SERVICETEKNOTES

TABLE OF CONTENTS

DM44, U3165 A/D I.C. REPLACEMENT (cont.)

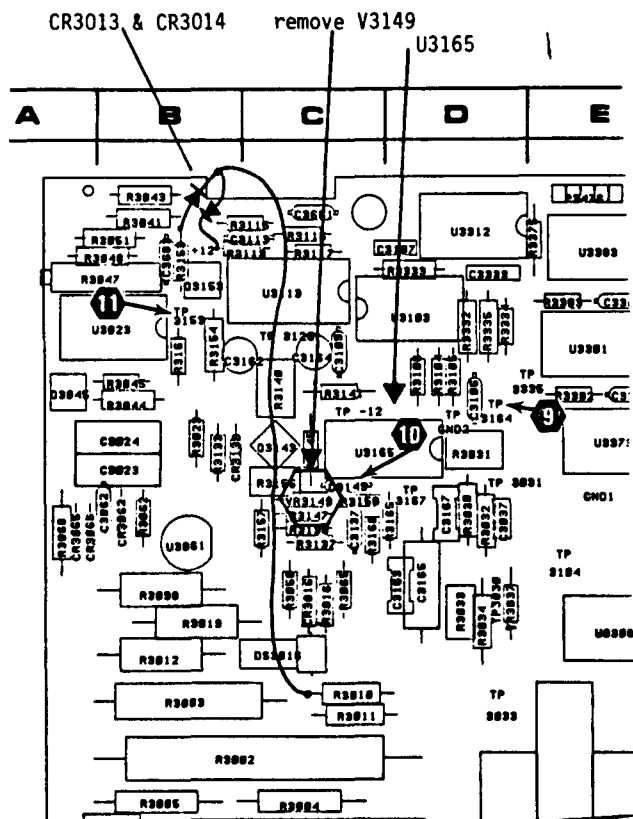
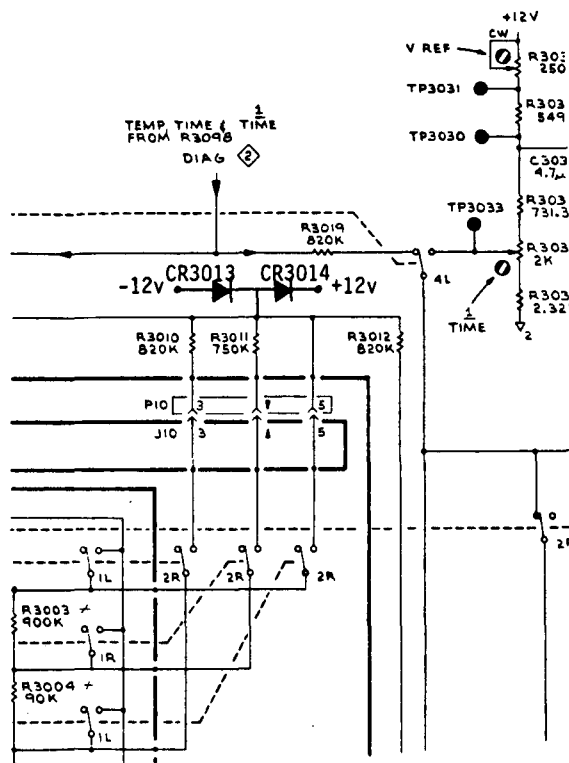
The old I.C., P/N 156-0477-00, used for the A/D processor, U3165, is no longer

available. A new I.C., P/N 156-1268-00, is now used for a replacement. The I.C. is not a direct replacement and the circuit must be modified as follows:

1. Remove VR3149
2. Add CR3013 & CR3014, P/N 152-0323-00, at location shown in the diagram. (CR3013 anode to R3153 [-12 volt supply], CR3014 cathode to R3113 [+12 volt supply], the two diodes are joined together and wired to R3010.)
3. Replace U3165.

GMA102A L.V.P.S. Q5008 MODIFICATION
542417

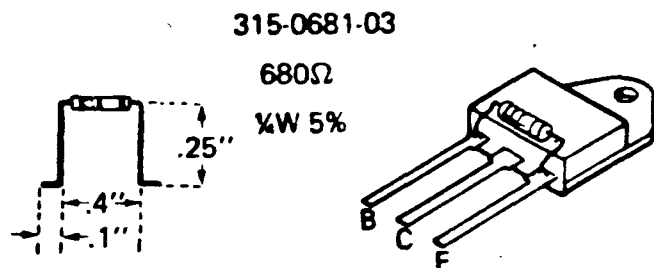
Early GMA102A Low Voltage Power Supplies (prior to serial number B060000) have shown a particular failure mode where R126, R127 and R129 overheat. Other components that typically fail as a result are CR681, Q101, R203, R210, R301, U221 and VR210. This failure occurs when the connector on the leads of Q5008 comes loose.

- Remove R210 (680 Ω , 315-0681-03) and VR210 (120 v zener) from the 670-5105-04 power supply board. The board level changes to -07 as a result.
 - Add another 680 Ω , 315-0681-03 resistor to Q5008 across the base-emitter junction (see figure). The leads of
- (ARTICLE CONTINUED ON THE NEXT PAGE)

R210 will be too short to use; the resistor must not obstruct connecting Q5008's socket.

SPG 2 BURST GAIN PHASE SHIFT

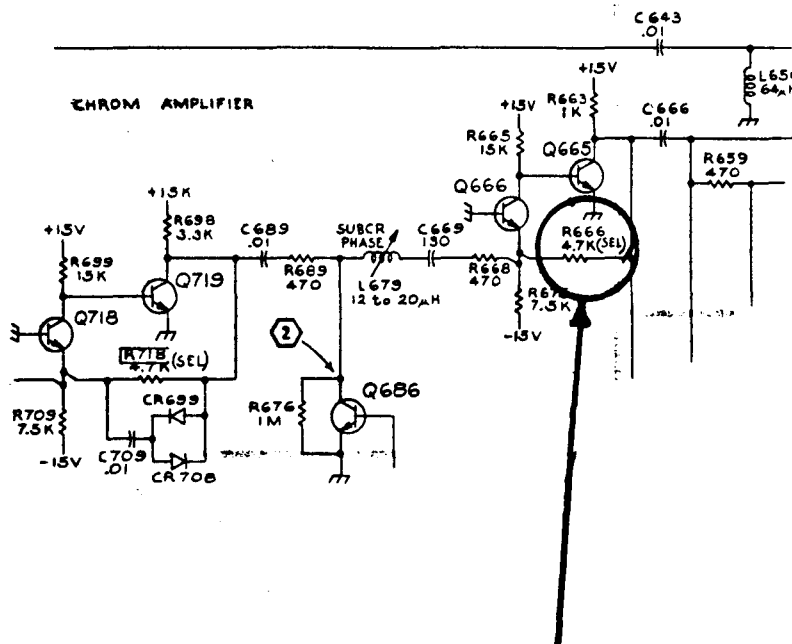
Transistors from different vendors are showing widely varying response characteristics (151-0190-00). This part is used in Q665, Q666, Q718, Q719 and Q715

In the past these transistors have had to be hand selected to keep phase shift with a change in burst gain within specifications.

The addition of a test selectable capacitor (C667, 281-0670-00, nominally 1.8pf) will help avoid this selection routine.

Add C667 in parallel with R666 and select a value between 0 and 4.7pf to obtain minimum phase change with burst gain change, as necessary. See the illustration.

TM5006: HIGH LOAD RELIABILITY IMPROVED

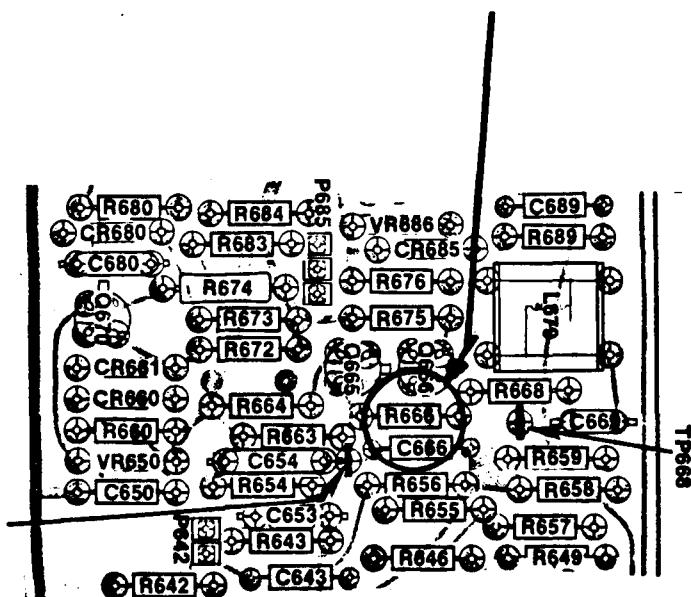
Switching transistors, AA11Q1640 and A111650 were changed from P/N 151-0632-00 to 151-0679-00. The new devices prove to be more reliable at high load and high temperature situations. In addition, A11R1530 and A11R1460 were changed from 2.2 ohm, 2W, P/N 308-0686-00 to 1.8 ohm, 2W, P/N 308-0703-00.

Also, to improve the cooling to A11CR500 in the +8V supply, the insulator plate was changed from 386-0786-00 at S/N B020400.

528 INTERMITTENT SWEEP & RGB

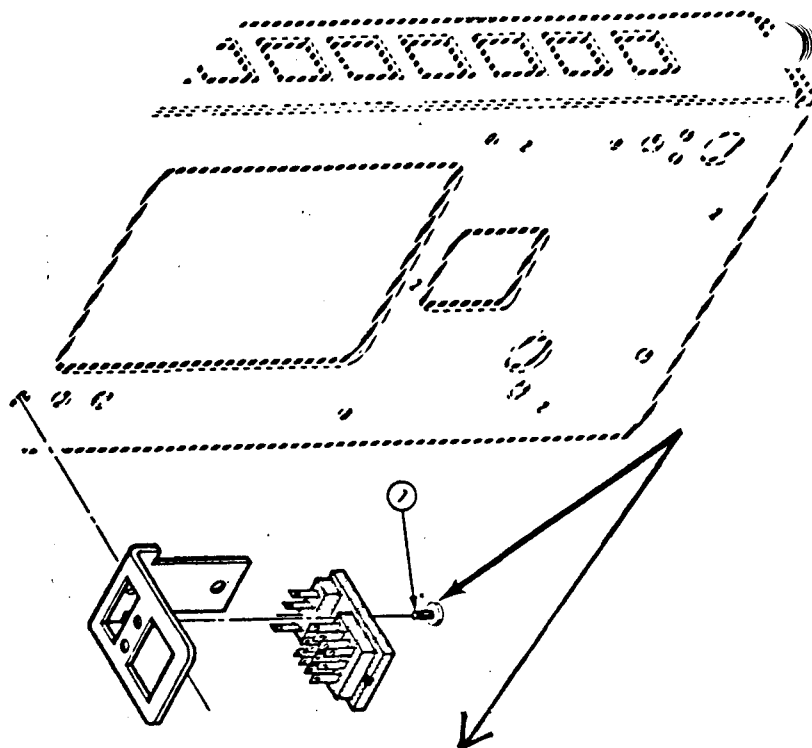
Intermittent sweep and RGB operation has often been caused by poor electrical contact in relay K370.

A new part is available for this application. Use P/N 148-0027-02.

1470 INTERMITTENT GENLOCK

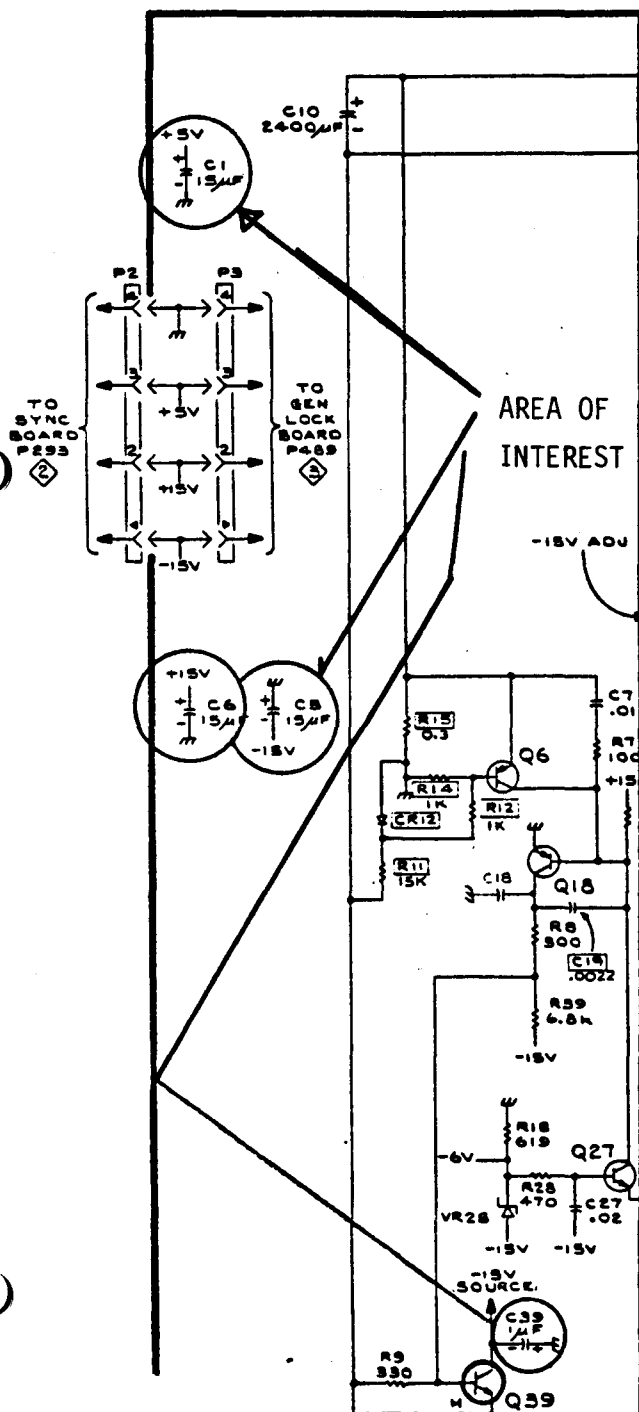
During subcarrier lock, when a loss of internal lock occurs and the 1470 switches to the internal mode, the switching may not be complete, causing the Unlock light to blink.

R447 has been selected to correct this in the past. Changing R447 to a 9.1K 5% 0.25w (315-0912-00) resistor will help alleviate the selection requirements.

4631: HARD COPY NOISE AND RAMP OSCILLATION MOD TO TIMING BOARDSymptoms

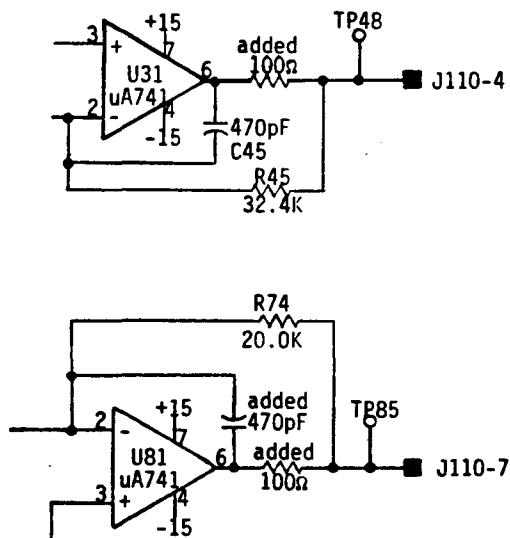
Hard copy image is noisy at the top, or weak at the bottom of the page. The "interrogate" scan line may be broken up (or a series of dots) at one end. The slow ramp may start one inch to the right of where it should start.

Load capacitance can cause the uA741 Op Amps--Slow and Fast Ramp Drivers--to oscillate. Usually this is due to long (ARTICLE CONTINUED ON THE NEXT PAGE)

Add 100 ohm resistors in series with the ramp outputs. Add a 470 pF capacitor from pin 6 (output) to pin 2 (inverting input) of U81. Note schematic corrections below.

1. Orient the board with edge connector toward you, component side up.
2. Lift pin 6 of U31. Lift the right end of C45 (on top of R45) and solder it to the lifted pin 6. Solder a 100 ohm, 1/4 w, 5% resistor, p.n. 315-0101-00, from the right end of R45 to the lifted pin 6, U31.
3. Lift pin 6 of U81. Solder a 470 pF capacitor, p.n. 281-0580-00 across

the top of U81 from pin 2 to the lifted pin 6. Solder a 100 ohm, 1/4w, 5% resistor, p.n. 315-0101-00, from lifted pin 6 to TP85.

4. Change the part number suffix of the board to 670-3661-09 or 670-5740-02.

Figure 2-6. Attached Parts Location.

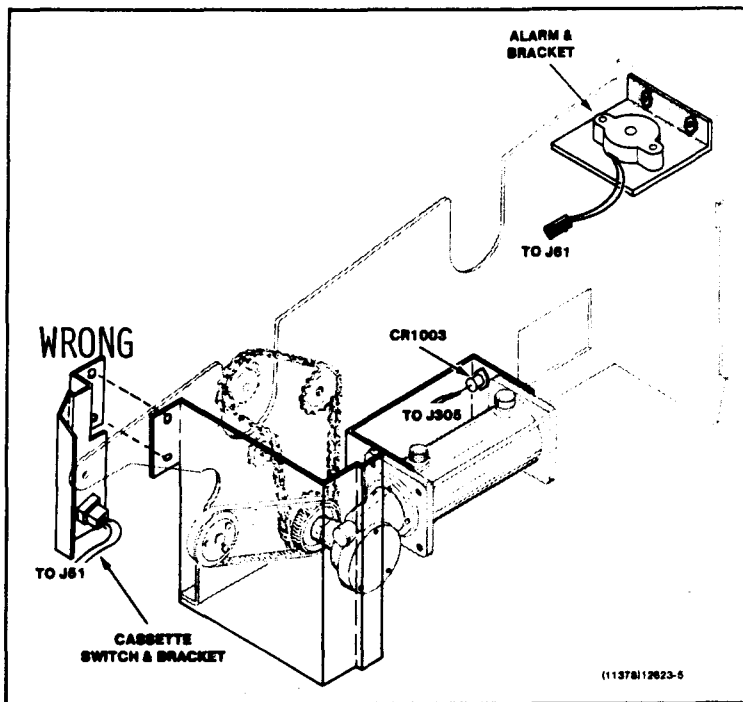
An error in the installation instructions for the (jam) Detector Board Kit, CM020-0814-00, may confuse both Tektronix and OEM customer service personnel. On page 2-9, Figure 2-6 shows the cassette switch bracket mounted to the left of a flange from the front subpanel. The correct mounting location is on the right side of the flange. The figures below should clarify.
